SUPERFUND THIRD FIVE-YEAR REVIEW REPORT

A.L. Taylor (Valley of Drums)

Brooks, Bullitt County, Kentucky

February 2003

Figure 5
ALT-03 Well Log

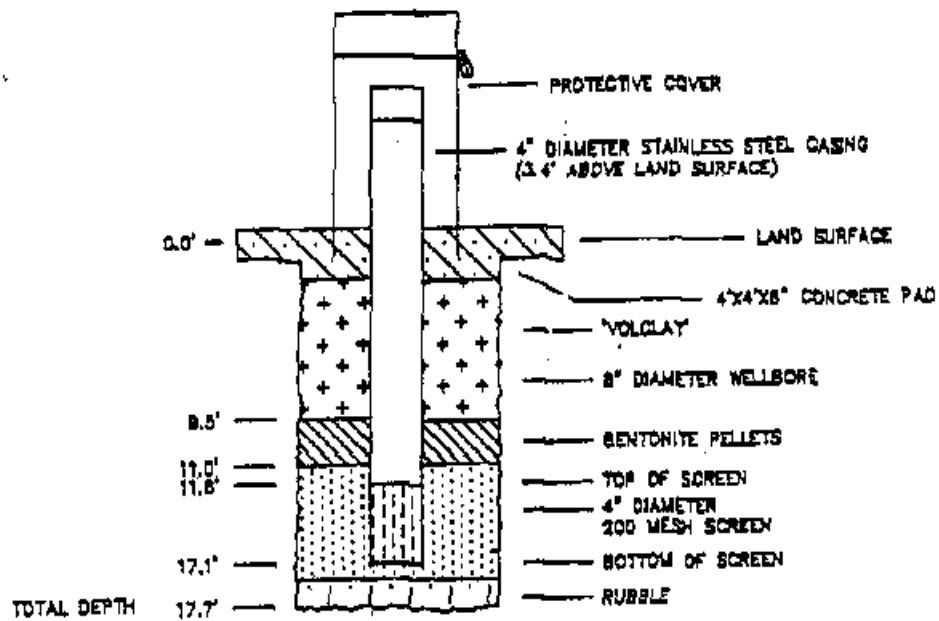
1. Well ALT-03 is a critical down-gradient sampling point known to have become fouled. Examination of the well section (Figure 5) indicates that the top of the well sand pack is less than 6-inches above the top of the well screen. For standard construction of wells it is preferred to have at least 2 feet of sand pack above the well screen to prevent the bentonite seal from impacting the screen. Based on the depth of the well, there is

sufficient room for 2 feet of sand pack and then the seal. The well has become fouled with silt and thus the well laboratory results could be in question. It is recommended that the well be surged and purged to remove the silt and the well re-developed and re-sampled. A replacement well may be necessary if ALT-03 cannot be re-developed.

Figure 6 – Sediment Sampling Locations
A.L. Taylor Superfund Site

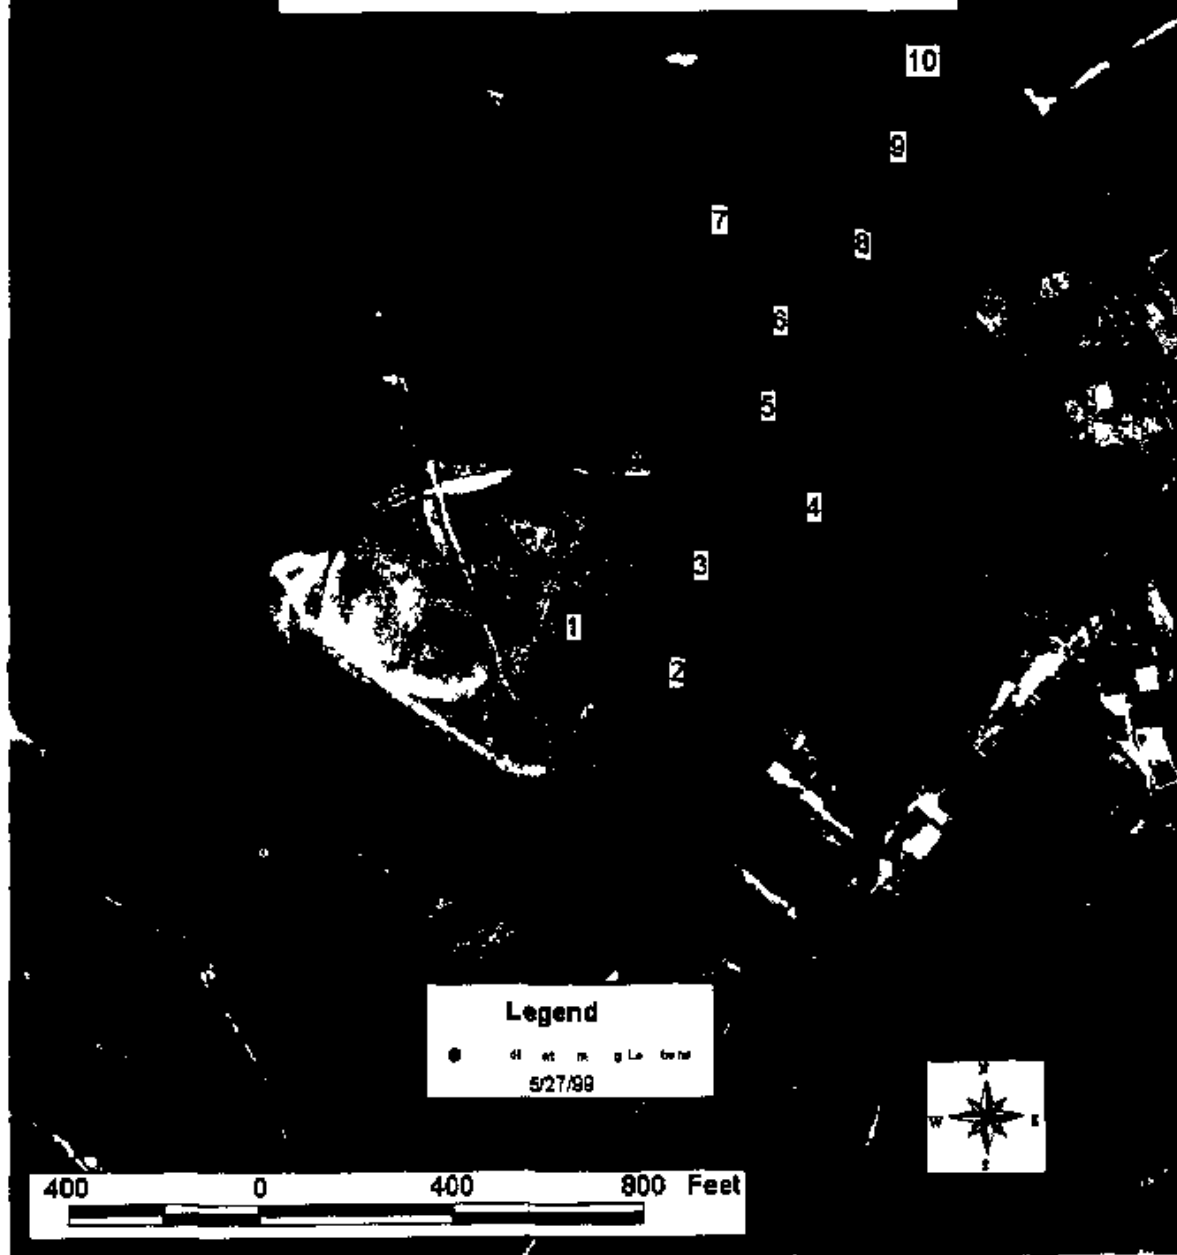
- Sediment samples were taken in Wilson Creek on January 8, 2003. Laboratory results reported 2.70 mg/Kg Aroclor 1254 from sample point SD-5 (Figure 6) and 1.27 mg/Kg Aroclor 1254 from sample point SD-9 (Figure 6).

Sediment. During the 1998 sampling, no PCBs were detected in sediment samples taken from sample points SD-06 (pond), SD-07 (north swale), SWD-08 (north ditch), SD-09 (south swale), SD-10 (pond outlet), or SD-11 (Wilson Creek downstream). During the 1999 sampling, Aroclor 1254 was detected in sediment samples taken from sample points 01, and 03 through 08. Aroclor was also detected at sampling points 02, 07, and 08 (Figure 6). Sediment samples taken in Wilson Creek on January 8, 2003, as part of the 2002 data collection effort, reported 2.70 mg/Kg Aroclor 1254 from sample point 05 and 1.27 mg/Kg Aroclor 1254 from sample point 49 (Figure 6).
